## CITY PLANNING COMMISSION

August 7, 2013/ Calendar No. 5

N 130212 ZRK

**IN THE MATTER OF** an application submitted by the Department of City Planning, pursuant to Section 201 of the New York City Charter, for an amendment of the Zoning Resolution of the City of New York, modifying Article II, Chapter 3 (Residential Bulk Regulations in Residence Districts) and Article III, Chapter 5 (Bulk Regulations for Mixed Buildings in Commercial Districts) in Portions of Community Districts 8 and 9, and concerning Appendix F (Inclusionary Housing Designated Areas) in Community District 8 in the Borough of Brooklyn.

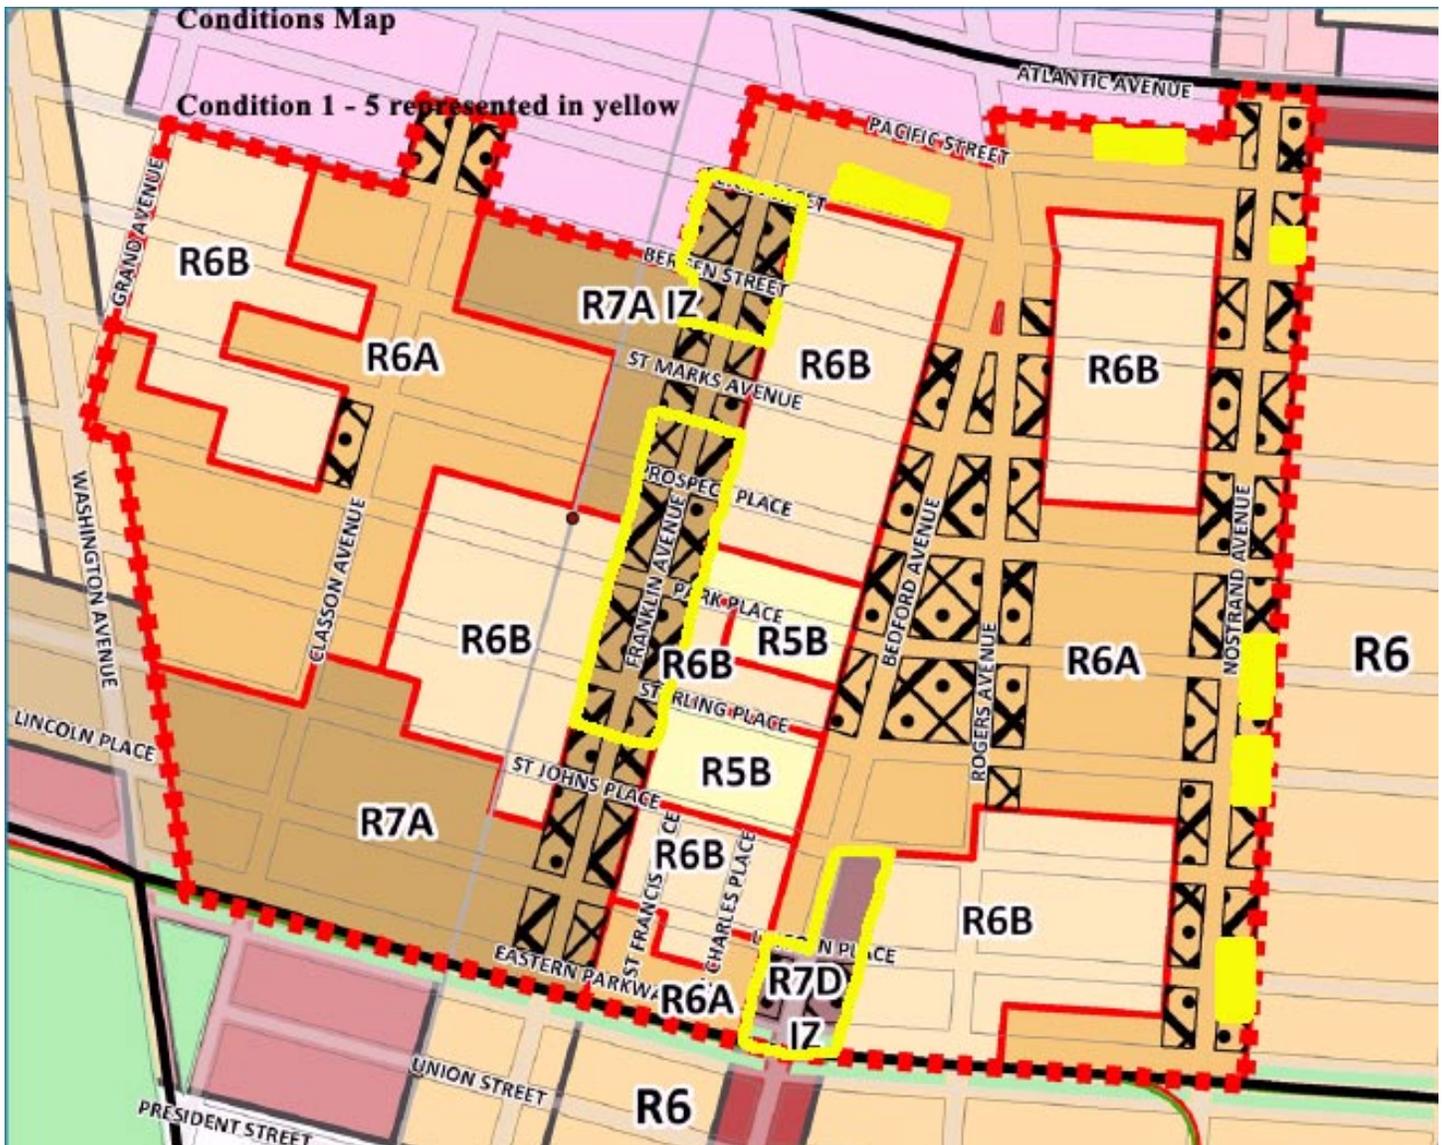
### Consider Establishing a Special Enhanced Commercial District along Franklin Avenue

Franklin Avenue is an emerging street for retailing, though it is possible that the proposed R7A zoning could tempt developers or property owners to redevelop sites that are substantially under-built, resulting in a significant amount of redevelopment. More than half the properties would be developed to less than 50 percent of the proposed base floor area and thus even small lots could potentially be attractive for investors. Without requirements to mandate retail or other active use for the ground floor, developers might opt to construct entirely residential condominium developments and not include active use on the ground floor.

The Borough President believes that any loss of retail frontage along Franklin Street could be detrimental for the entire corridor. He believes that this commercial street would benefit from being regulated by the Special Enhanced Commercial District regulations and believes DCP should pursue such a study as part of any east of Nostrand Avenue rezoning for Crown Heights North.
